# GO FOR THE GOLD!

THE M16 RIFLE AND THE M4/M4A1 CARBINE CAN NOW USE THE SAME EXTRACTOR SPRING ASSEMBLY.

New extractor spring is gold with a black insert

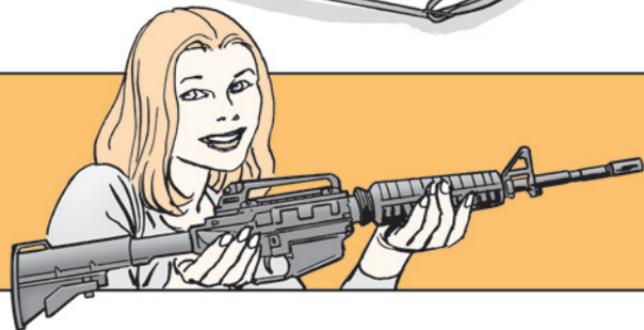
THAT MEANS IN THE NEAR FUTURE THE M16 AND M4 WILL ALSO USE THE SAME BREECH BOLT ASSEMBLY.

The old extractor spring assembly, NSN 5360-01-424-5899, is still in stock and may be ordered for use only on the M16. The old breech bolt assembly, NSN 1005-01-422-3770, is also still in stock and may be ordered only for the M16.

Once stock of the two assemblies are exhausted, order only the newer extractor spring assembly, NSN 5360-01-505-2886. It's gold colored—the old one is dark colored. Order the new breech bolt assembly with NSN 1005-01-505-1035.
